January 8, 2009
BKF No. 20050061-10

SUBJECT: Laurel Way Planned Development
Storm Drainage Analyses
Response to Peer Review Comments

Subject	LAUREL WAY JOINT VENTURE		
	FIGURE 1		
Job No.	20050061		
By	MD	Date	12/23/08 Chkd. RH
		SHEET	1 OF 2

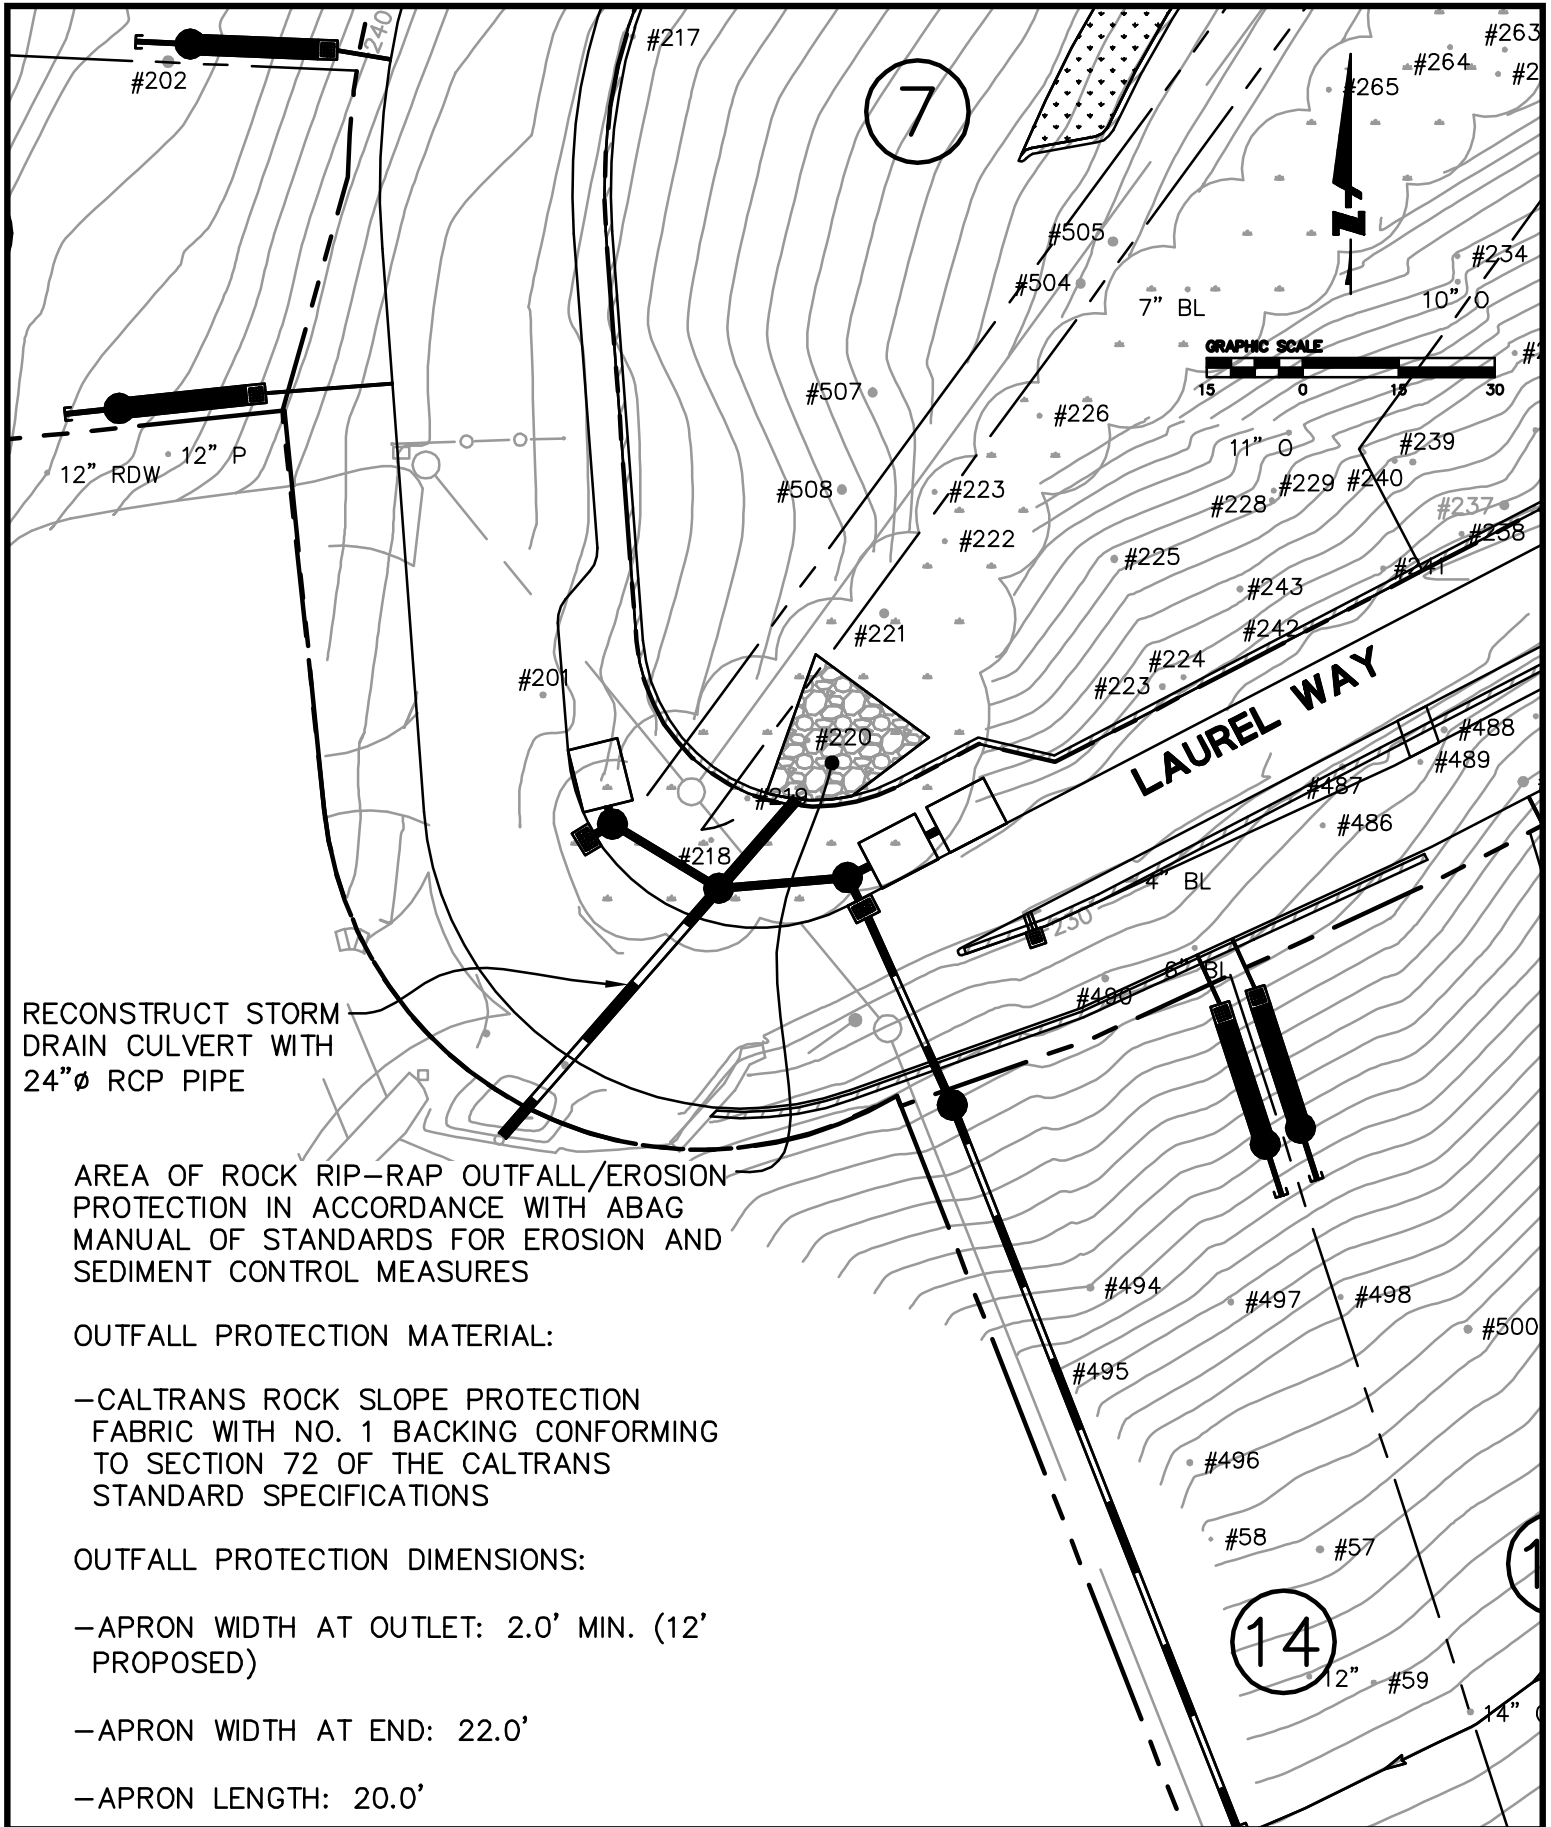
- B1. Comment: Flow from Lots 11 through 13 may bypass the Filterra Unit.

Response: A revision is proposed to place a catch basin on the north side of the street that will discharge flows to a proposed curb drain on the south side of the street. The revision is shown on Figure 1. The Filterra units are sized to treat runoff from rainfall events up to 0.2 inches per hour. Lots 11 through 13 and roadway have a total drainage area of 1.0 acres. The peak flow rate during the treatment storm event will be about 0.2 cfs or 890 gpm. Because of the small flow rate, the velocity would be less than 3 feet per second in the gutter, even with the 8.6 percent slope. A standard catch basin can be used to capture the gutter flow.

Subject LAUREL WAY JOINT VENTURE
FIGURE 2
Job No. 20050061
By MD Date 12/23/08 Chkd. RH
SHEET 2 OF 2

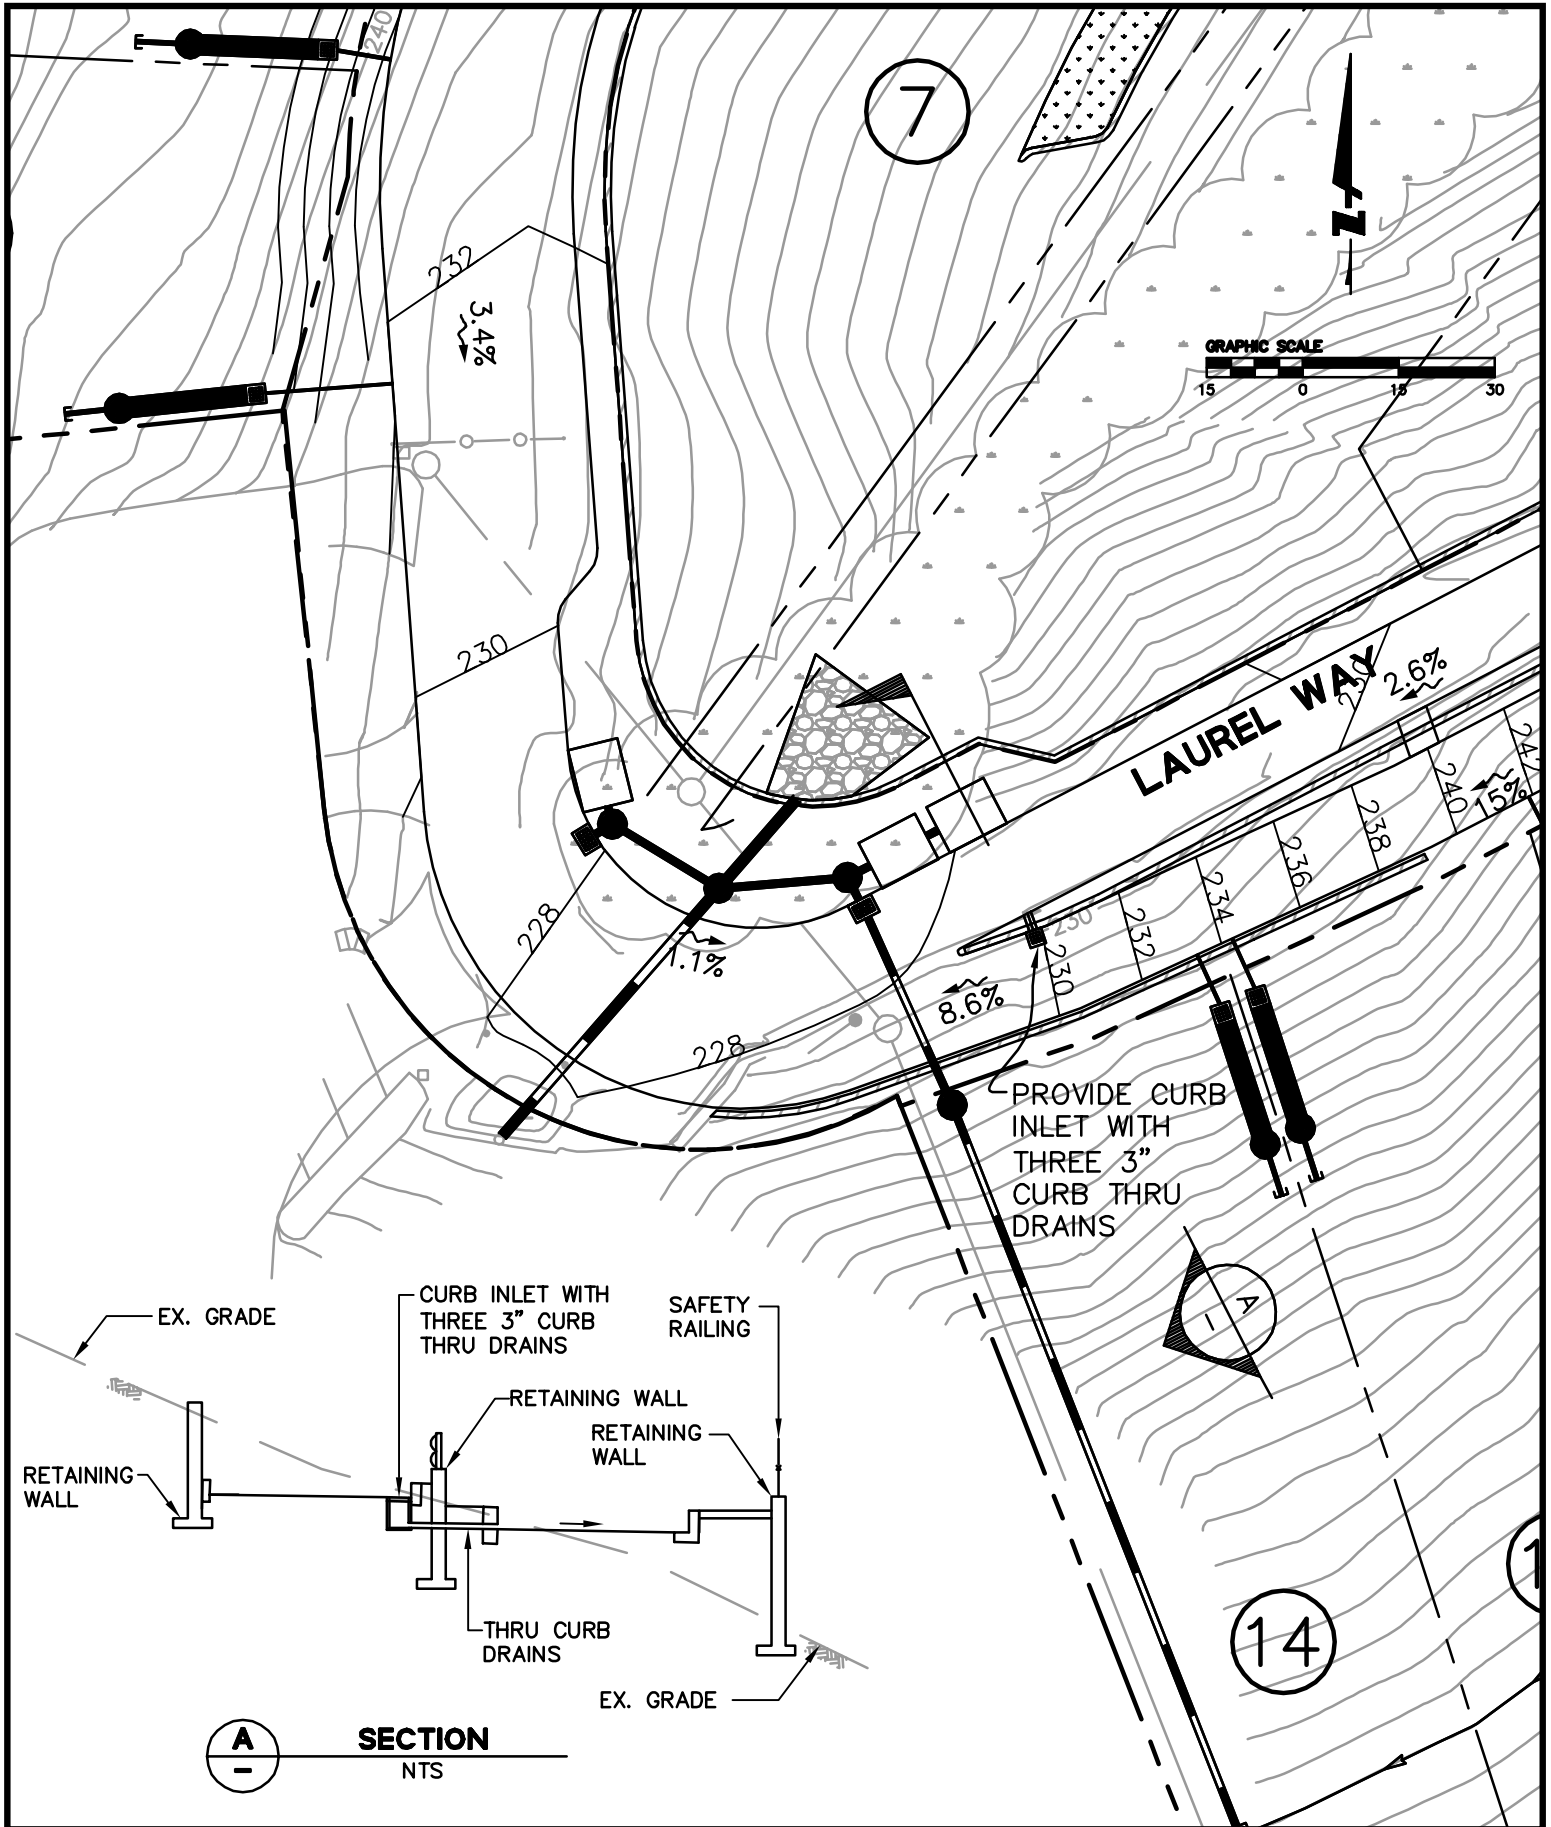
- B2. Comment: No energy dissipater is shown below the replacement 24-inch line.

Response: To the extent feasible, the existing energy dissipation facilities at the existing storm drain system outfall will be used. As a part of Final Design, these facilities will be surveyed. Figure 2 shows energy dissipation facilities based on the ABAG Standards. If the existing facilities are not adequate, supplemental protection will be provided as shown. Final design will be confirmed at the time of construction document preparation and review by City of Redwood City Engineering Department
